Addendum No. 2

April 24, 2018 Play Area Improvements at Verdugo Woodlands, R.D. White, Muir, and Balboa Elementary Schools Bid Number 170-17/18

Changes to Scope of Work:

1 FREE STANDING CMU WALL SCALE: N.T.S.

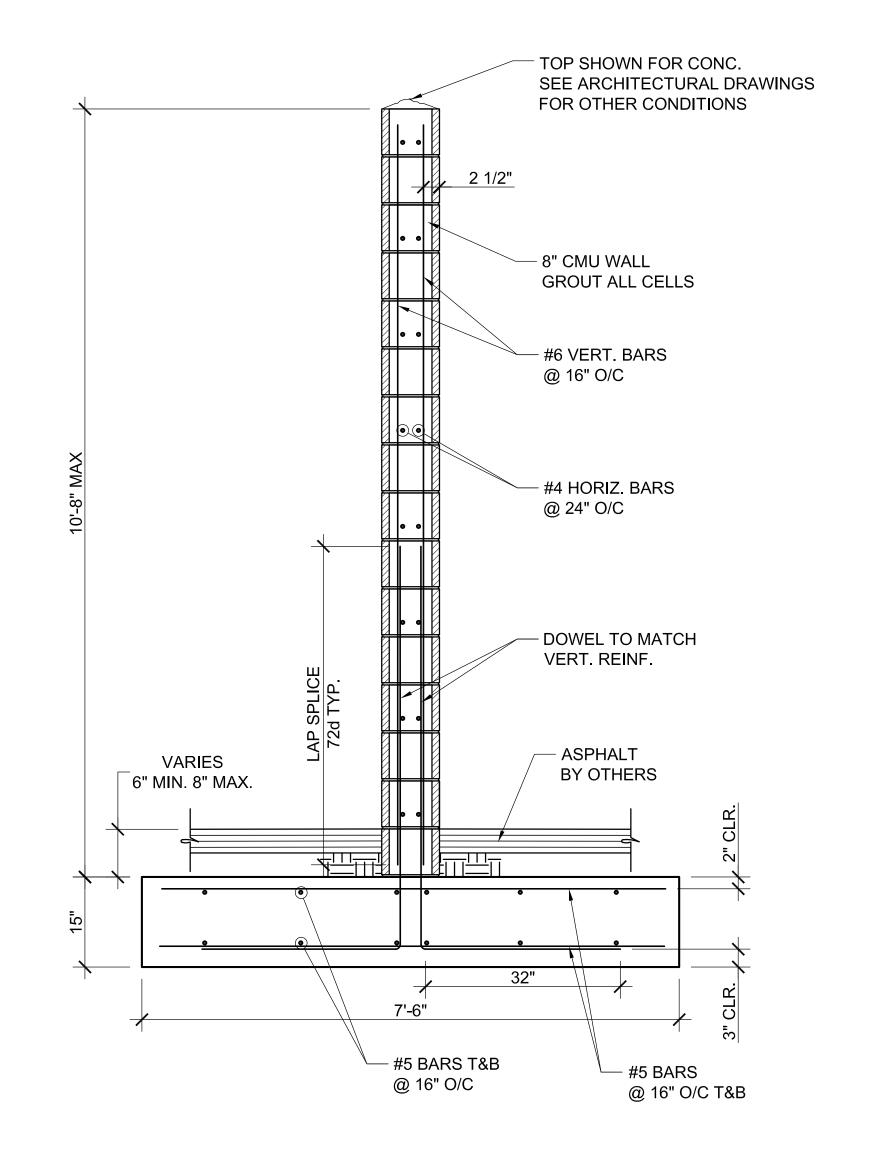
Add ball wall at Lincoln Elementary School per attached details and drawing.
